1 First Floor Plan As Proposed
Scale 1:50 @ A1 / 1:100 @ A3

2 Second Floor Plan As Proposed
Scale 1:50 @ A1 / 1:100 @ A3

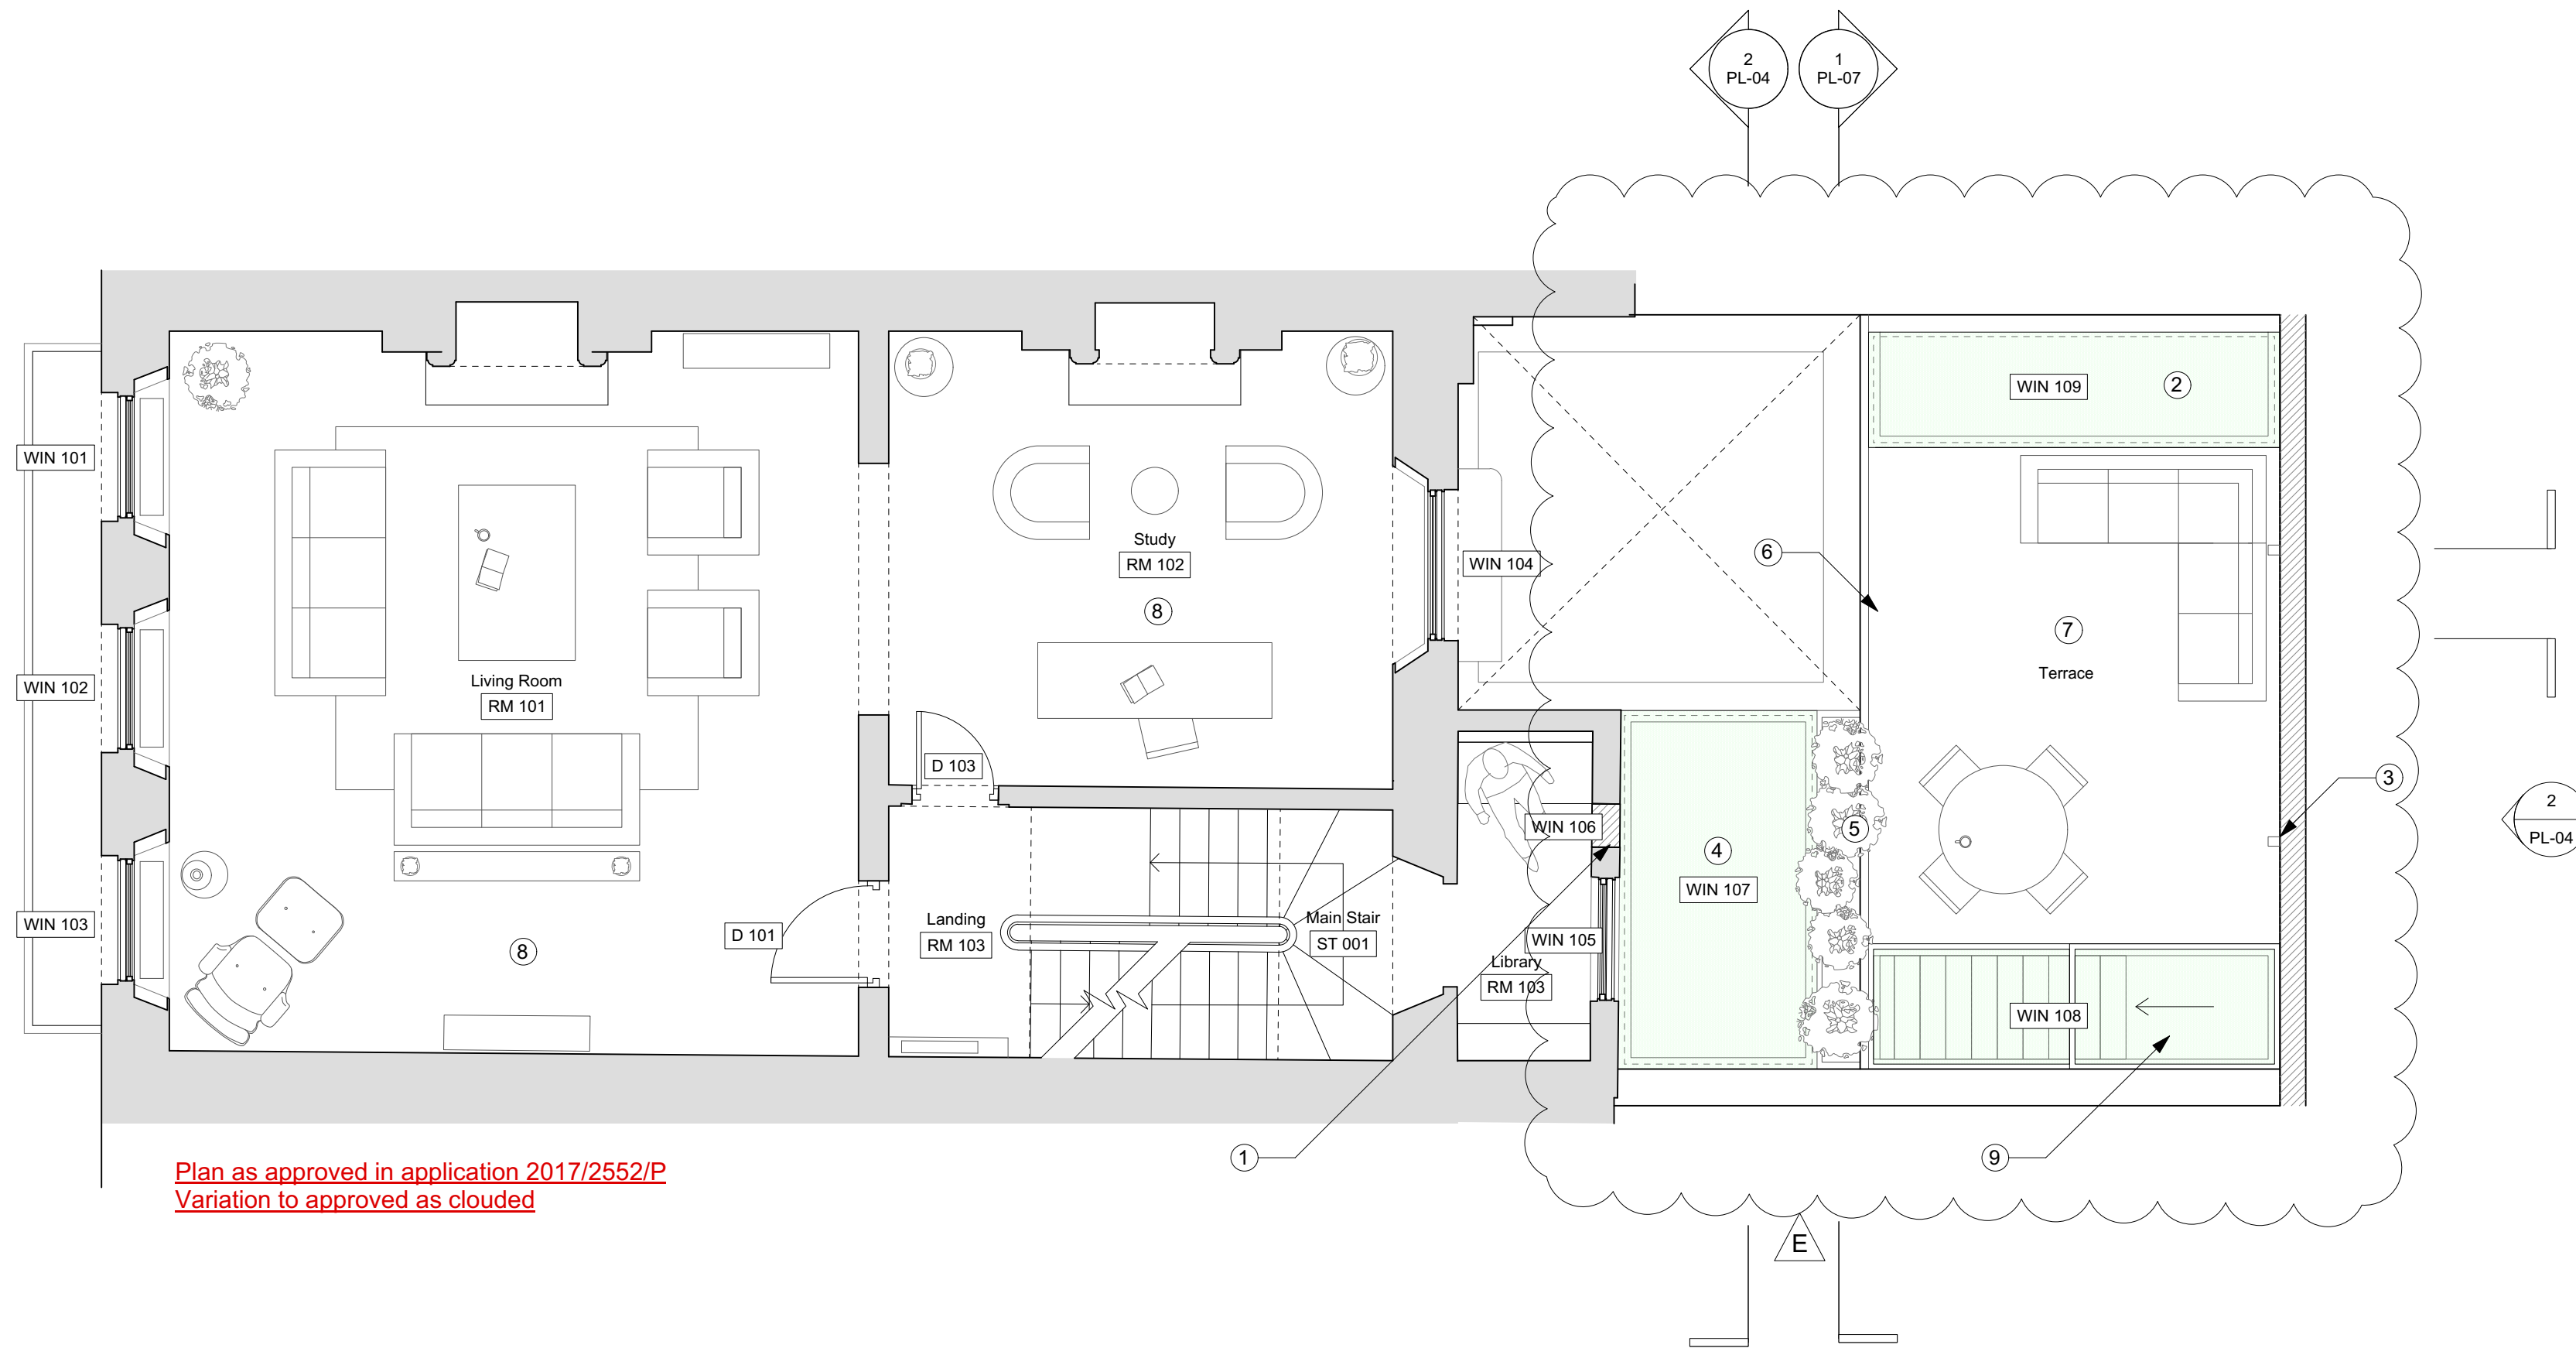
Plan as approved in application 2017/2552/P
Variation to approved as clouded

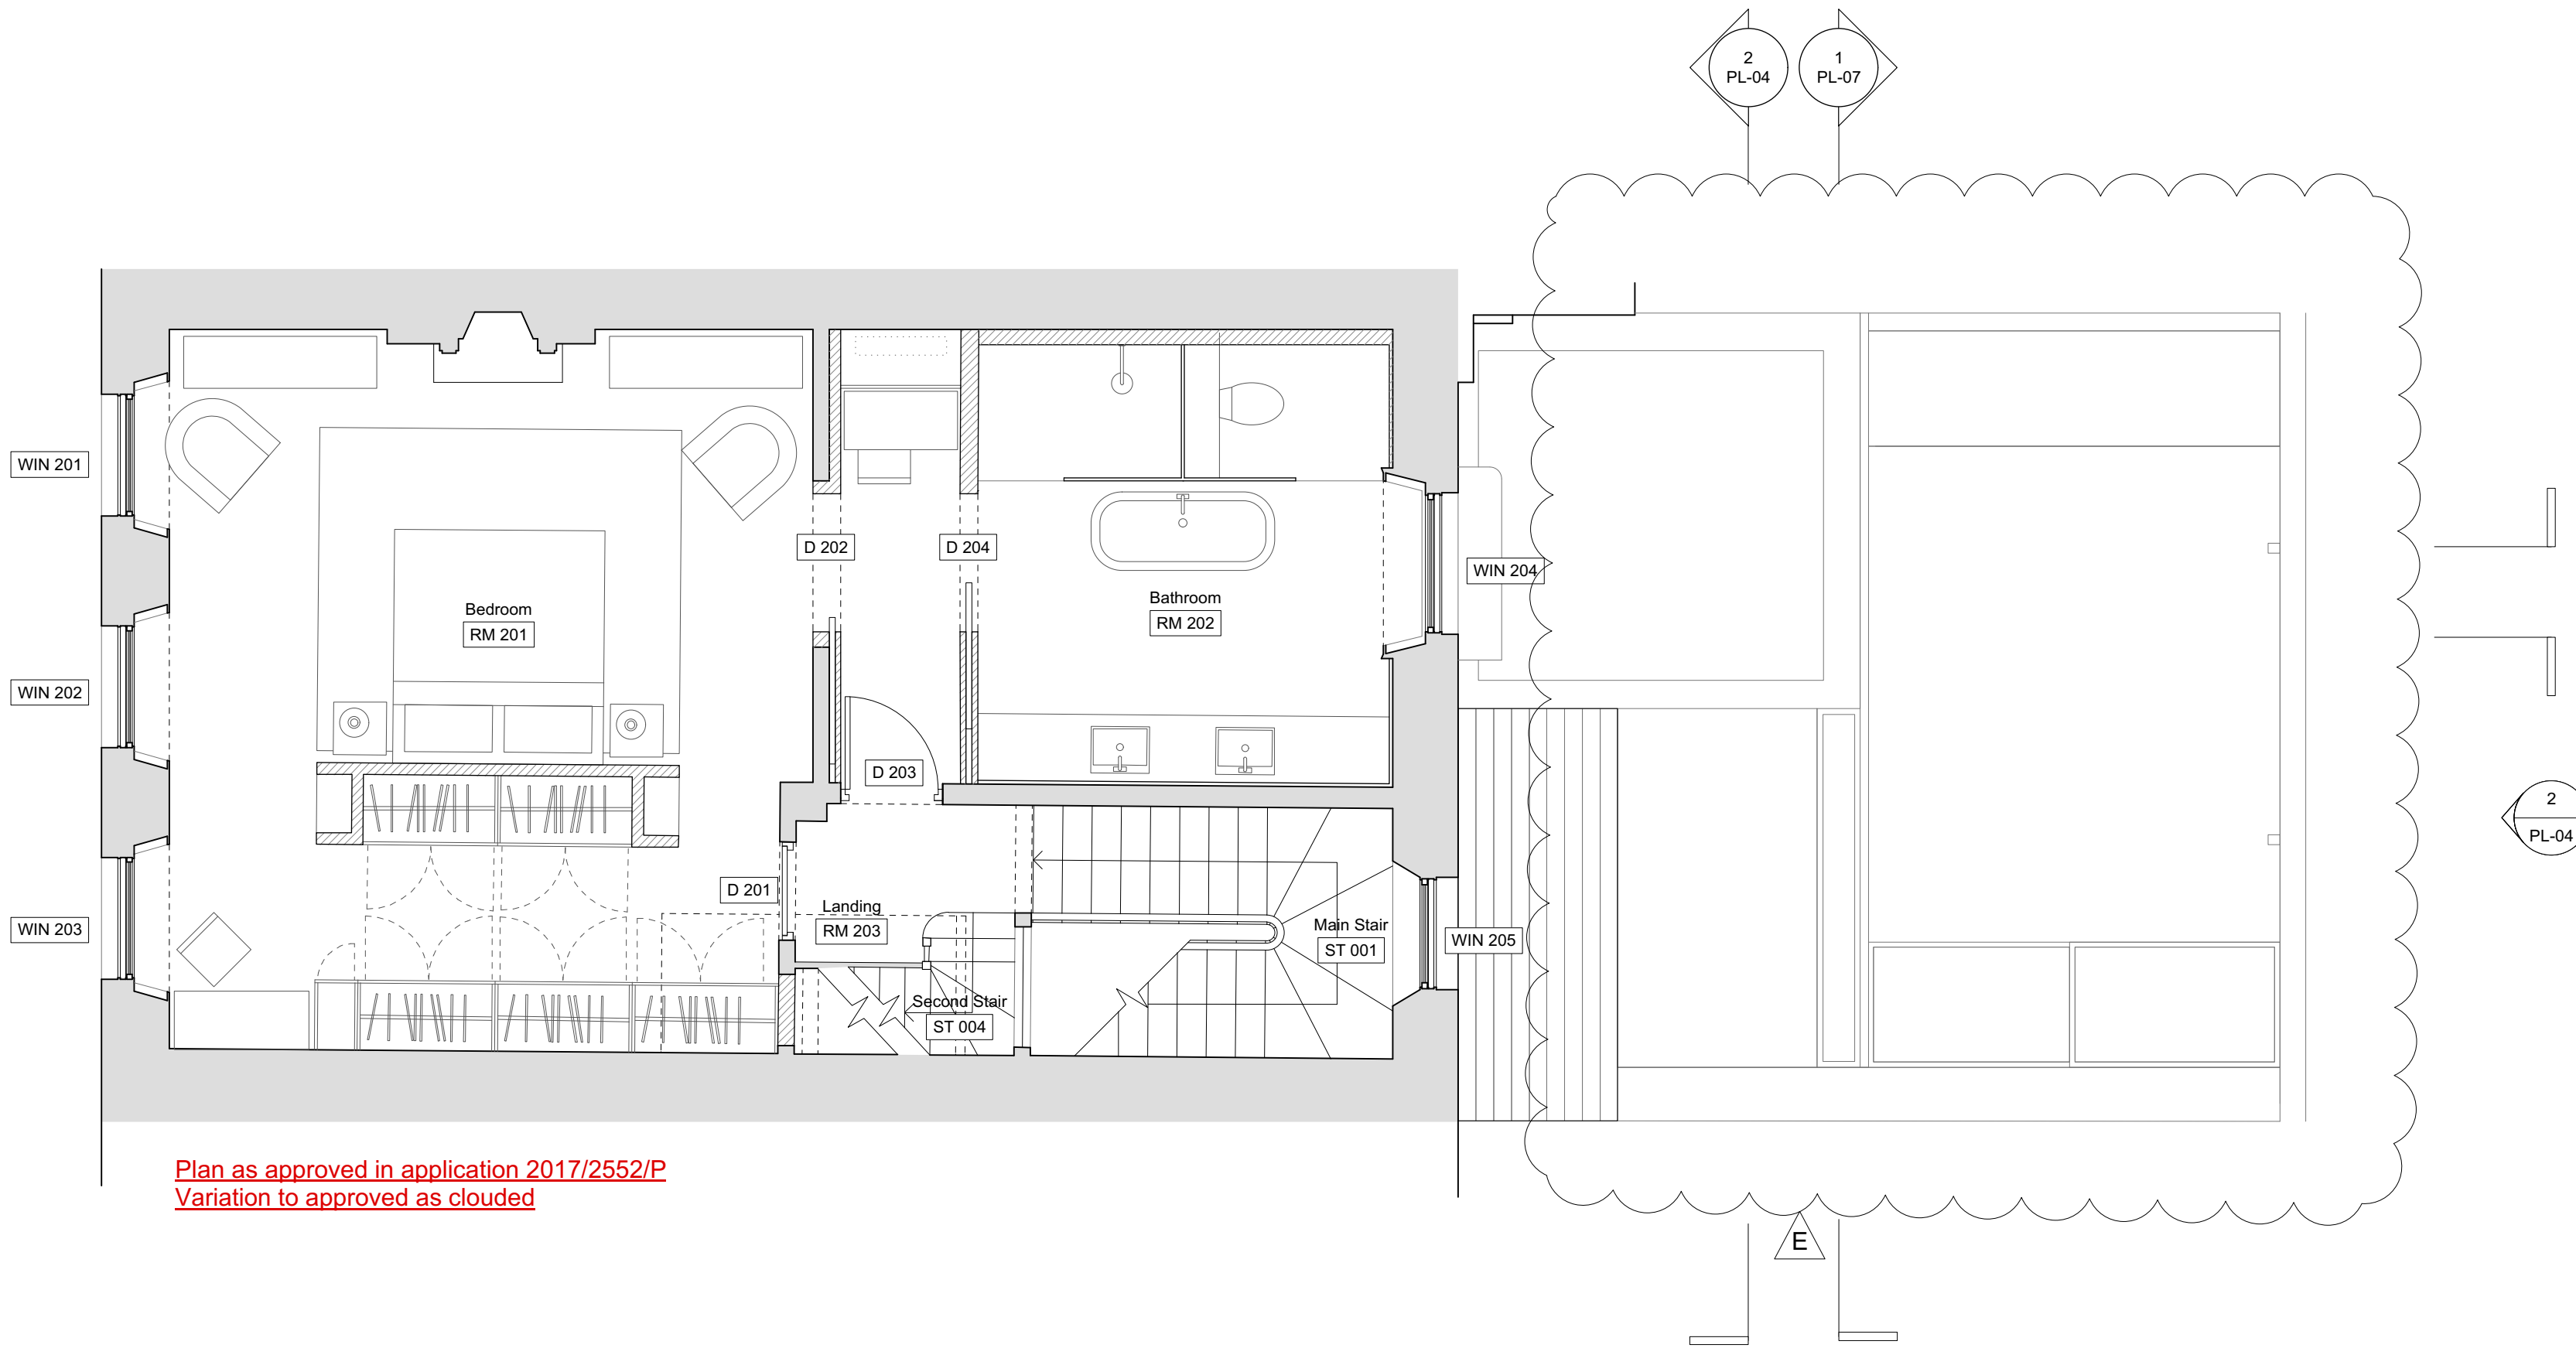
Plan as approved in application 2017/2552/P
Variation to approved as clouded
